UNITED STATES PATENT AND TRADEMARK OFFICE

| APPLICATION NO. | FILING DATE | FIRST NAMED INVENTOR | ATTORNEY DOCKET NO. | CONFIRMATION NO. |
|-----------------|-------------|----------------------|---------------------|------------------|
| 10/613,842 | 07/03/2003 | Daryl E. Anderson | 200208831-1 | 6766 |

| Office Action Summary | Application No. | Applicant(s) | |

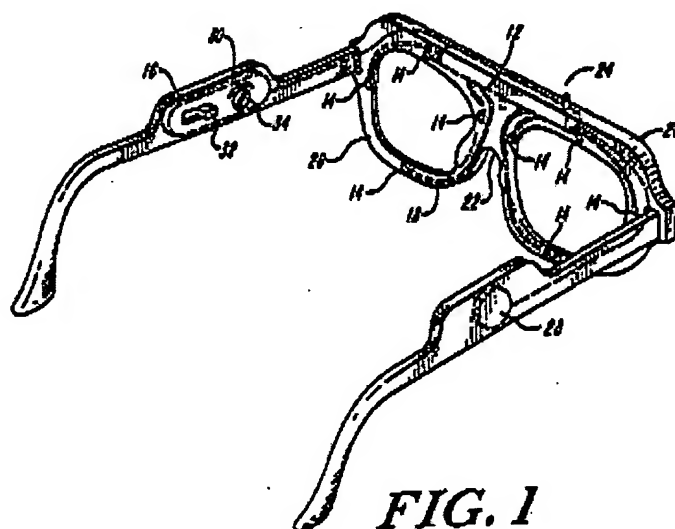
Bertera teaches a spectacle style frame that includes means for introducing fluid to the eyes of a wearer (see figure 1, infra).

Bertera teaches a spectacle-like device (10) that includes thermal or piezoelectric jet dispensers (14) to apply treating fluid into an eye (col. 5, lines 1-12; col. 9, lines 3-17)(see figure 1, supra).

FIG. 11

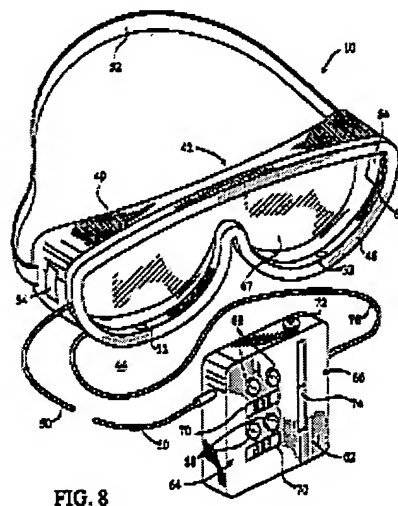
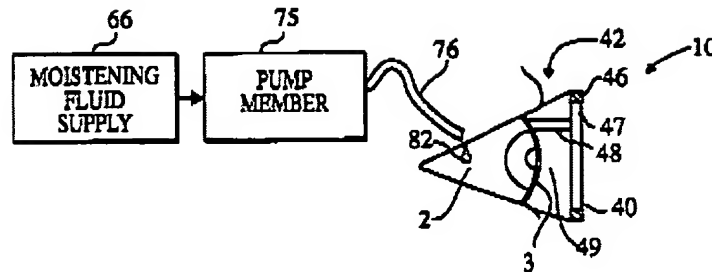
Regarding claims 1, Yee teaches an eye-positioning device (10) capable of assisting a subject in positioning an eye (2)(to an open or closed position of the eye; also, the visual indicator on the monitor (6) can be used to draw a patient's focus); and

An applicator capable (60, 66, 75, 76) of dispensing fluid into an eye (2)(see figures 8 and 11, infra).

Regarding claims 9, 10 and 22, Yee teaches a spectacle frame (40) and a fluid dispenser (60) supported by the frame (40)(figure 8).

FIG. 4

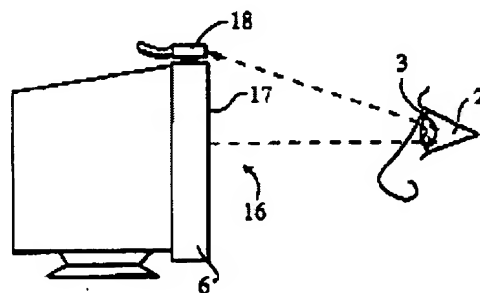
Regarding claim 5, Yee teaches a display monitor (6) (see figure 4, infra). A conventional computer display monitor is capable of displaying an image of an eye.
